CONTRACT No. 1800

WET WEATHER PUMP STATION

ADDENDUM No. 2

WET WEATHER PUMP STATION PROJECT

000-C-23
PAVING AND LANDSCAPING PLAN

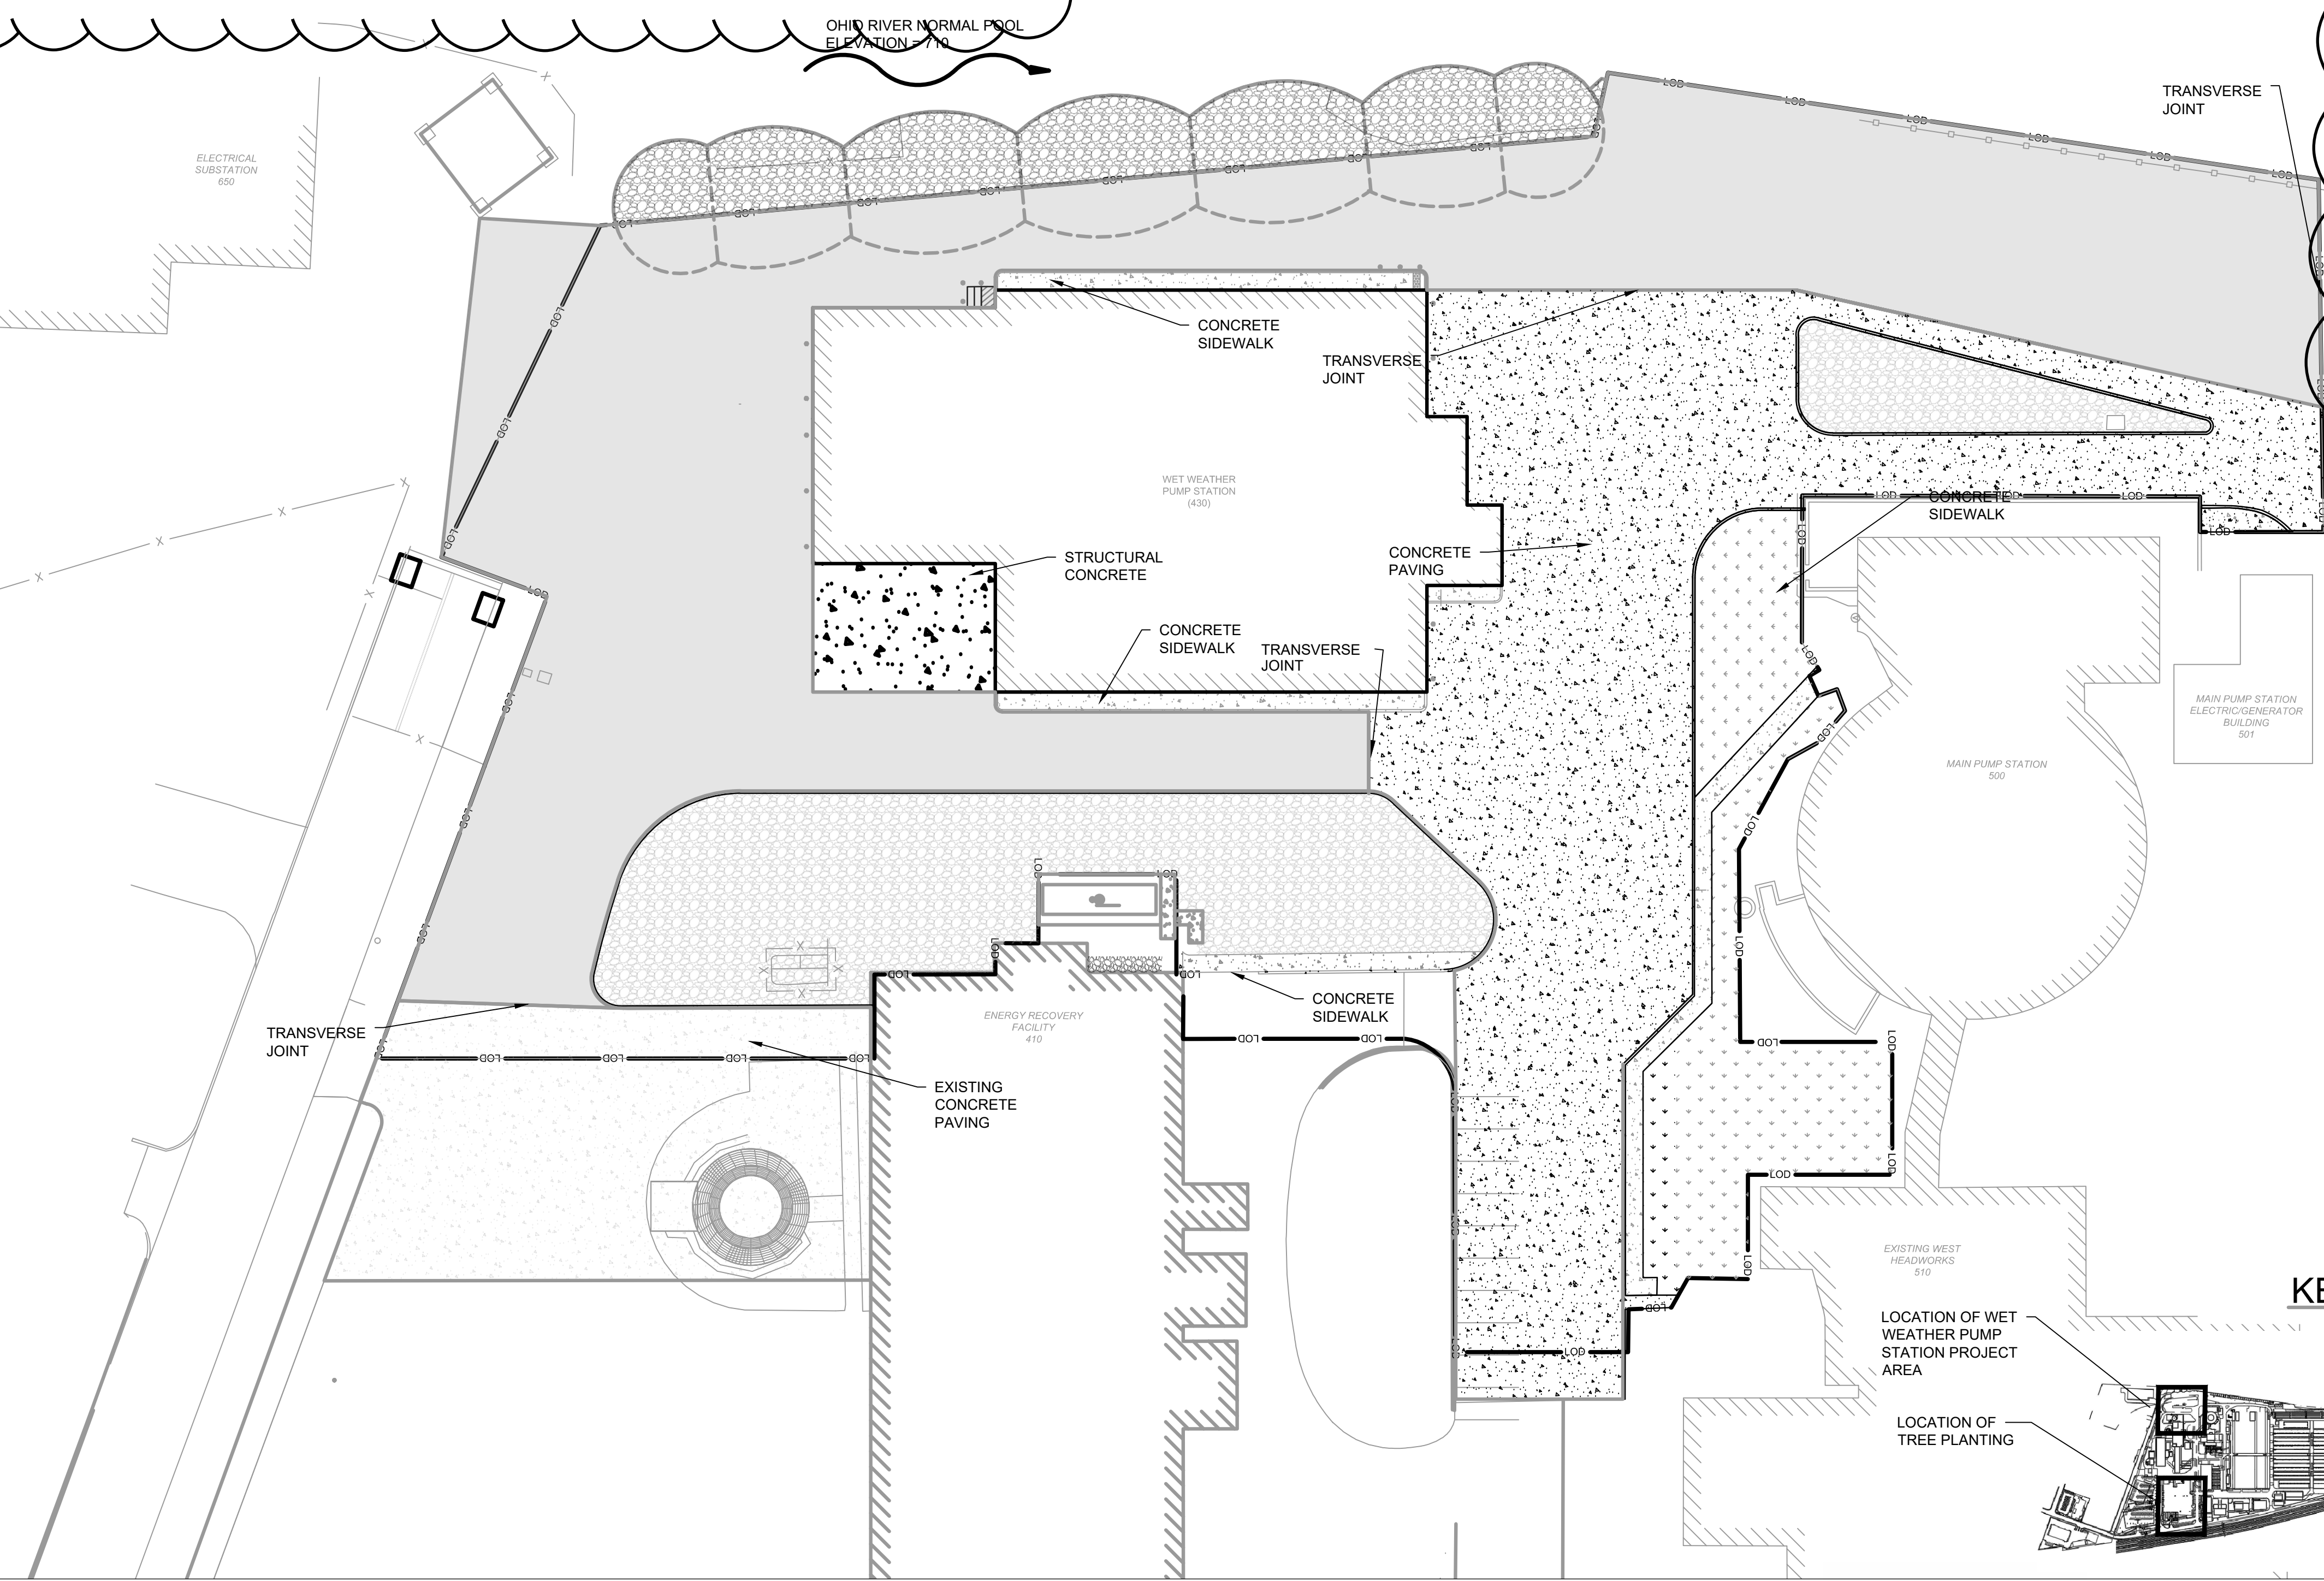
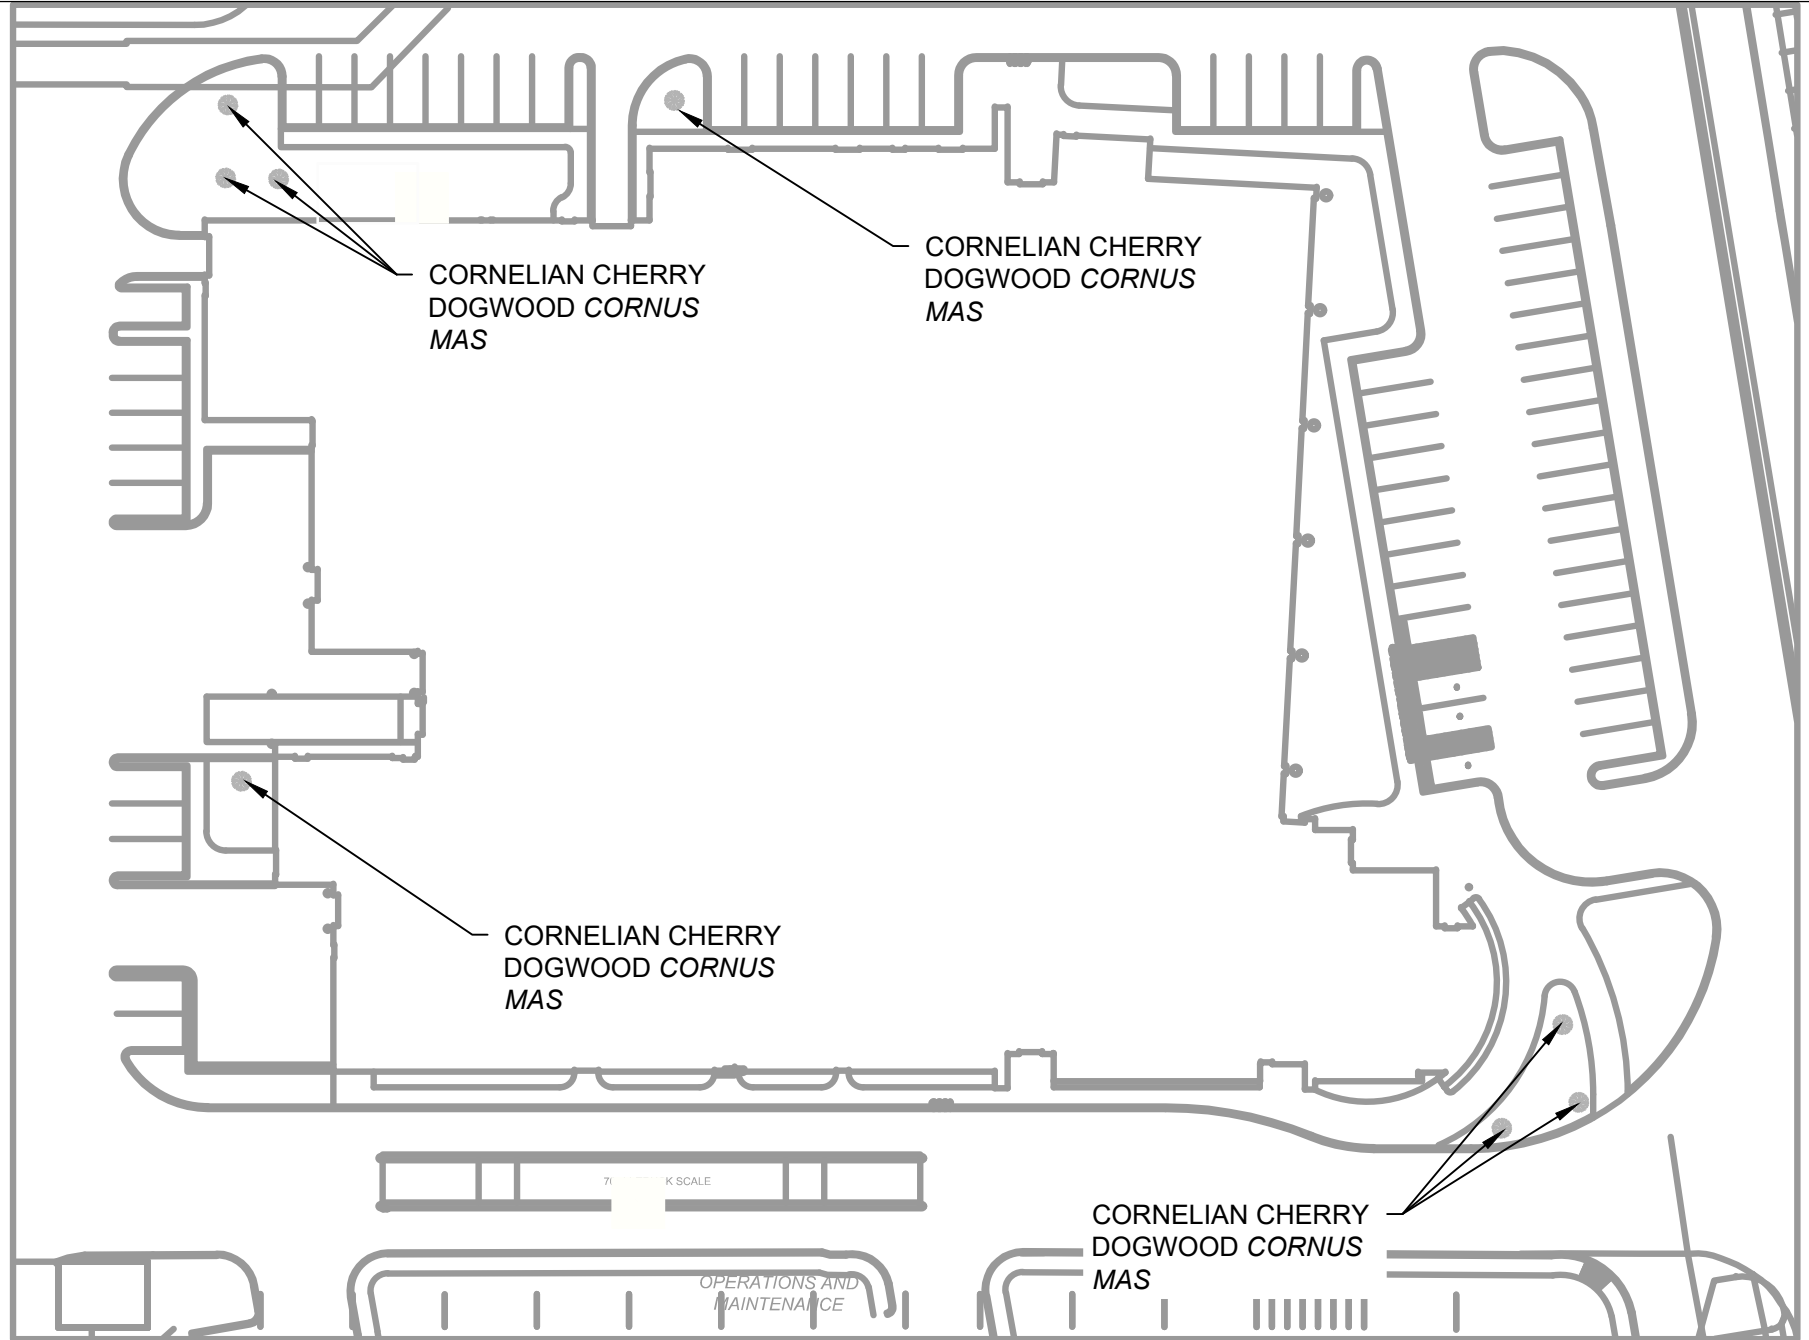
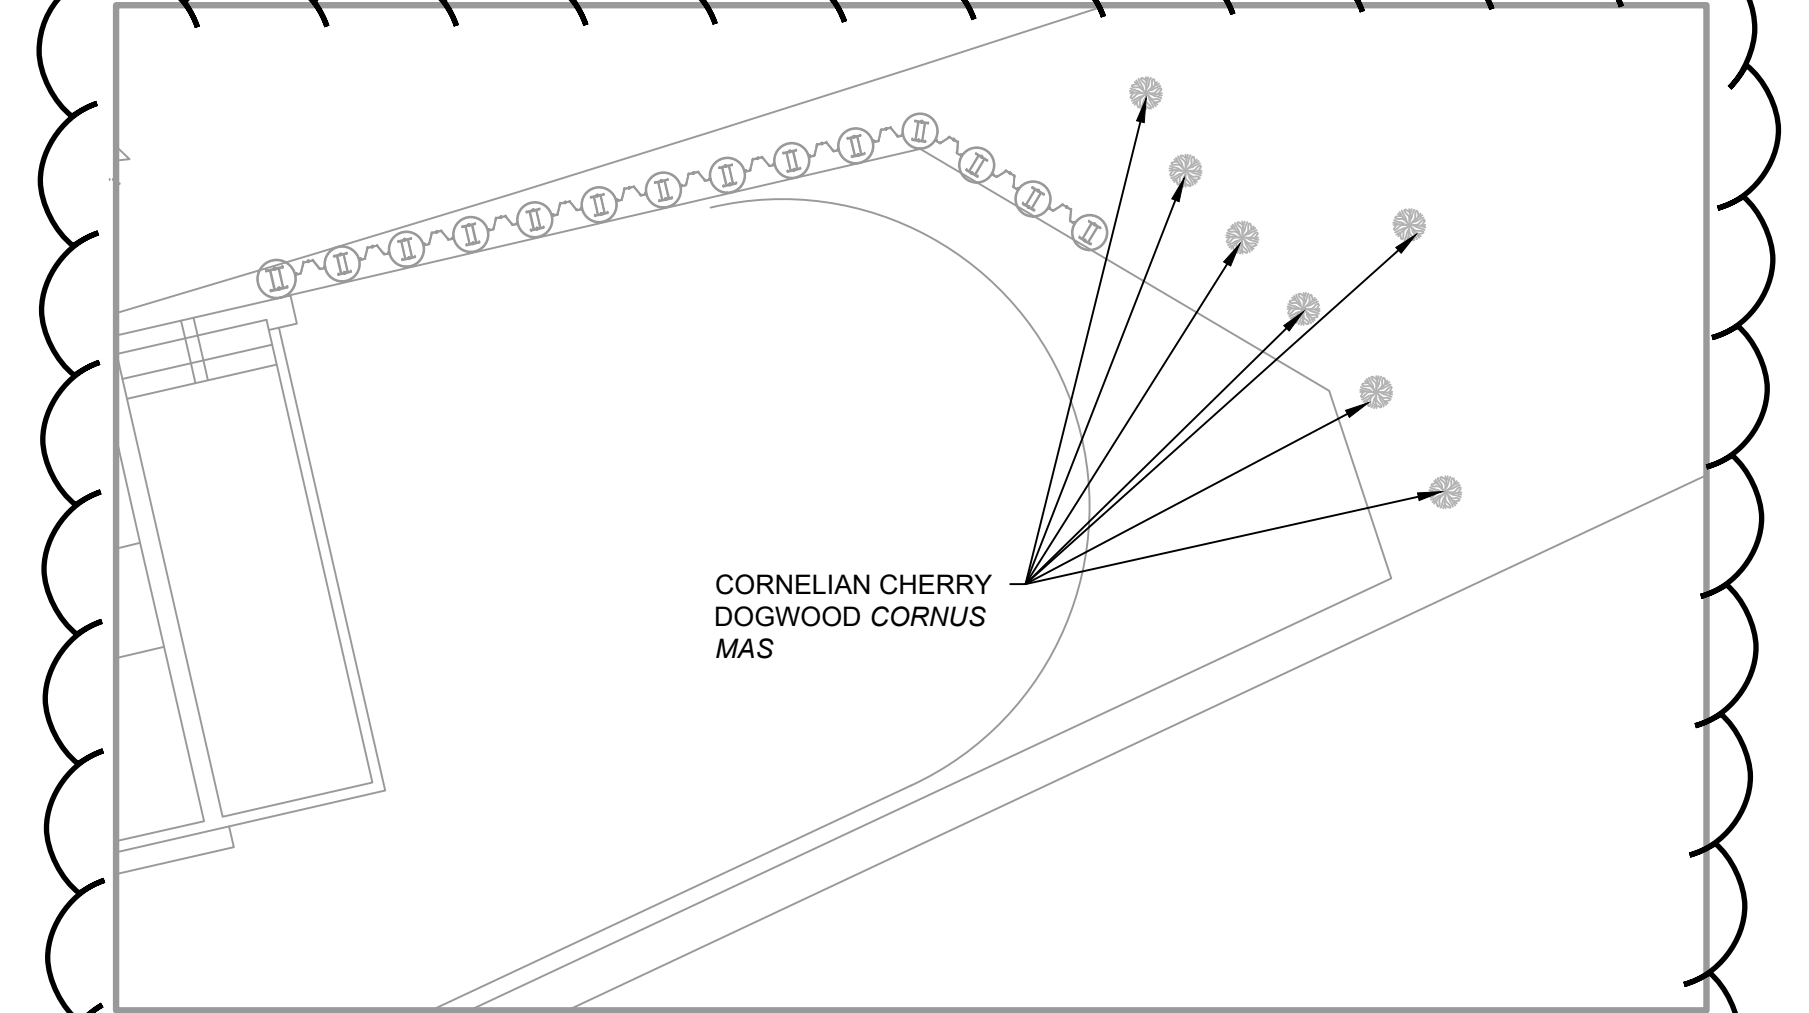
- 3.1 On Sheet 000-C-23, **ADD** trees at new locations. **REPLACE** Sheet 000-C-23 with Sheet 000-C-23 Rev. 01, refer to Attachment C.
- 3.2 On Sheet 430-M-03, **UPDATE** orientation of motor terminal enclosures. **REPLACE** Sheet 430-M-03 with Sheet 430-M-03 Rev. 01, refer to Attachment C.
- 3.3 On Sheet 430-ET-03, **UPDATE** orientation of motor terminal enclosures and power connection. **REPLACE** Sheet 430-ET-03 with Sheet 430-ET-03 Rev. 01, refer to Attachment C.
- 3.4 On Sheet 000-ESP-04, **UPDATE** size of manhole EMH-224. **REPLACE** Sheet 000-ESP-04 with Sheet 000-ESP-04 Rev. 01, Refer to Attachment C.
- 3.5 On Sheet 430-ED-03, **UPDATE** Details 1 and 2. **REPLACE** Sheet 430-ED-03 with Sheet 430-ED-03 Rev. 01, refer to Attachment C.
